Interactive comment on “Homogenizing and Estimating the Uncertainty in NOAA’s Long Term Vertical Ozone Profile Records Measured with the Electrochemical Concentration Cell Ozonesonde” by Chance W. Sterling et al.

Chance W. Sterling et al.

Received and published: 7 March 2018

Fig. 1. Figure 1: The eight long-term NOAA ozonesonde stations with Latitude, Longitude, # of Profiles, and launch period.

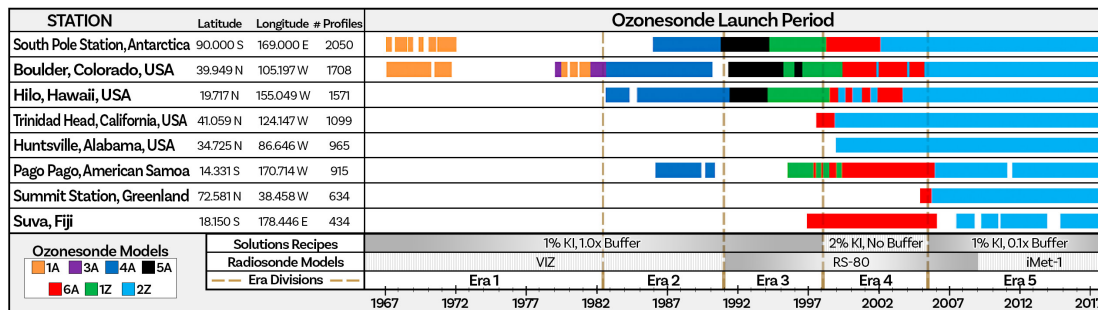
6: please use consistently either hPa or mb through the manuscript. I would propose to use hPa. Authors' Response: Changed all mentions of mb to hPa. ¶ Page 7, line 12: "Figure 1 shows the many changes to the NOAA ozonesonde record." As a matter of fact, Figure 1 does not show all those changes, but just gives an idea of the length of and gaps in the time series of the different NOAA stations. It would be nice to have a graphical or tabular overview of those different changes, see my next point. Authors' Response: Figure 1 has been updated to show the eras and the changes in ozonesonde type, solution type, and radiosonde type. ¶ Page 7, lines 15-25: the definition of the different Eras is described here, but a separate table (or graph) presenting the different characteristics of each Era is really needed, and not hidden as legends in Fig. 2 for example. This separate table (or graph) will make it also easier to follow the discussion of the homogenization, uncertainty analysis and comparison with Dobson and SBUV throughout the paper. Authors' Response: Figure 1 now conveys the Eras and the different characteristics of each. ¶ Page 10, lines 28-31: Before making this statement, please refer to Figure 3 ("Figure 3 shows the different climatological flowrate corrections CPF,SM, expressed in percentages.") . To me, it seems that in Figure 3, only for Boulder, the flowrate corrections w/ Dry Air (please spell out "with") are more stable than those obtained without the Drierite air purifier/desiccant filter. But Figure 3 is very tiny, and it is hard to distinguish between the different symbols (circles and diamonds) and between some colours (Boulder/Samoa & South Pole/Huntsville). Authors' Response: The statement "Figure 3 shows the different climatological flowrate corrections CPF,SM, expressed in percentages." has been added to what is now Page 11 Line 8. Figure 3 has been updated to increase the size of the symbols, the size of the graph, and to spell out with. The stability or variation and the uncertainty of the flowrate correction for the surface measurement depend on different factors. The uncertainty of the flowrate correction is based on the uncertainty of the ambient temperature and pressure of the room, the uncertainty of the humidity of the air stream being sampled, and the uncertainty of the pump/ambient temperature difference. The stability of the flowrate

Fig. 2. Figure S1: Average Boulder profile for Era 3 processed with the 1986 Komhyr processing and the NOAA ozone sensor efficiency processing techniques, Panel A. The percent difference in the two processing

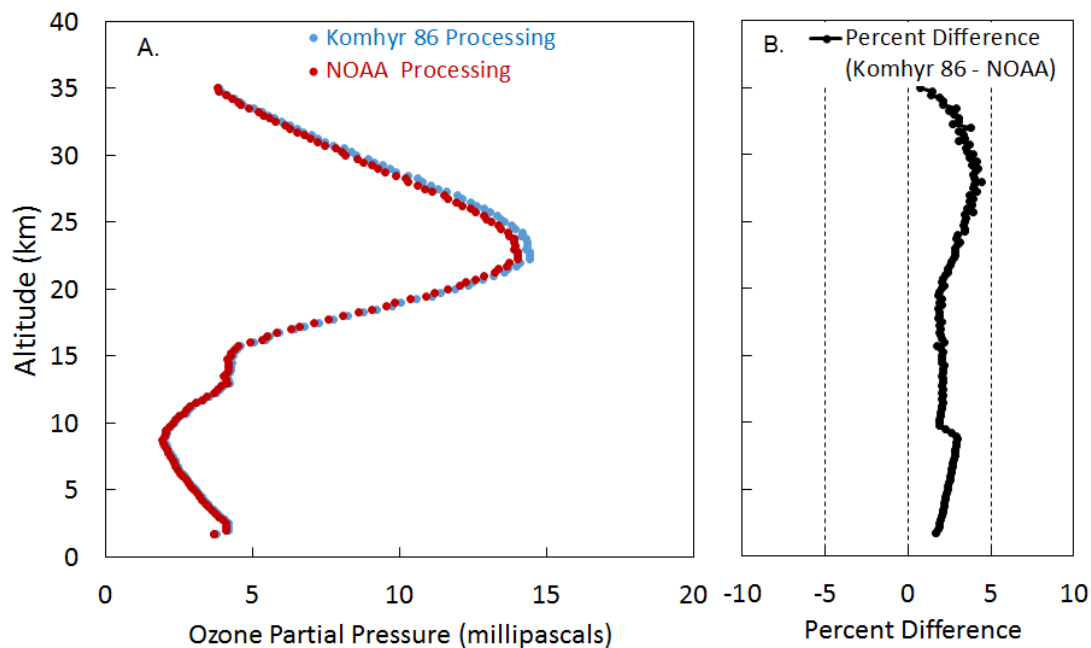
very well written manuscript (although it is somewhat lengthy at some places). The authors give a nice historical overview of the ozonesonde measurements and describe in a very clear way the different instrumental effects that have to be taken into account in the homogenization process. The uncertainty analysis, developed within the O3SDQA activity, has been applied on the profiles recorded at the NOAA network and has been presented extensively. The impact of the homogenization of the ozonesonde data record has been assessed with Dobson total ozone data and with SBUV profile measurements. So, the research is really well established. One of the major new achievements of the paper is the proposed approach of taking the measured (higher than the historical) pump flowrate corrections and correcting for the ozone sensor efficiency, which is derived from the comparisons of ozonesondes and the reference UV photometer at JOSIE campaigns. This is an alternative approach as the current O3S-DQA guidelines, which have set two standards (SPC 1% KI 1.0B and EN-SCI 0.5%KI 0.5B), which, with two different (historical, low) pump flowrate corrections, are within a few percent from the UV photometer at JOSIE. The authors argue that, a positive bias in the ozone sensor measurements, created by side reactions of the phosphate buffers, has to be compensated by using too low pump flowrate corrections. However, as these guidelines are still in use today, I would propose that the authors apply the O3S-DQA corrections strictly for the Eras in which one of those standards is used at NOAA sites (parts of Eras 1, 2, 3 are using the SPC 1% KI 1.0B) –so using the Komhyr (1986) pump flow correction factors – and compare those corrections with their proposed corrections (applying Eq. (15), which is based on 6 simulated flights during JOSIE 1996). By e.g. showing the average (and standard deviations) of the differences between the vertical profiles corrected by either approach, the authors should be able to demonstrate that their approach is equivalent to the O3S-DQA guidelines.

Authors' Response: The reviewer makes a good point about a difference in the processing methods of NOAA and other ozonesonde sites during Eras 1, 2, and 3. NOAA desires to be consistent with its processing methods throughout the record, so chooses to keep the Johnson 2002 pump efficiencies and ozone sensor efficiency based on the

cumulative ozone exposure. To assess the difference in the processing techniques, Era 3 for Boulder, CO and Hilo, HI were processed with each processing technique and compared. Two new figures (Figures S1 and S2) have been included in the supplementary material as well as a new sentence discussing the difference in the 1986 Komhyr processing method and the NOAA Accumulating Buffer Bias Correction. The figure plots the average Boulder and Hilo ozone profiles processed with both methods and a % Difference plot for each. The difference is less than the uncertainty for these data, so we have deemed it negligible. Additionally, the 1986 Komhyr processing method would increase the partial pressure of ozone in comparison to the NOAA approach. This increase would make the comparison with the ozone photometer at JOSIE worse and the comparison with the SBUV measurements worse. What is now Page 15 Line 4 now includes, "NOAA's approach (ozone sensor efficiency) differs from the ASOPOS standard processing for SPC ozonesondes paired with 1.0% KI, 1.0X Buffer Solution (1986 Komhyr corrections) in Eras 1, 2, and 3. To compare the two processing methods, the average profiles for Boulder and Hilo for Era 3 are shown in panel A of Figures S1 and S2, respectively, processed with the NOAA approach and the ASOPOS approach. The percent difference is included on panel B of the plots and the difference is less than the uncertainty of the ozone measurement for these eras."
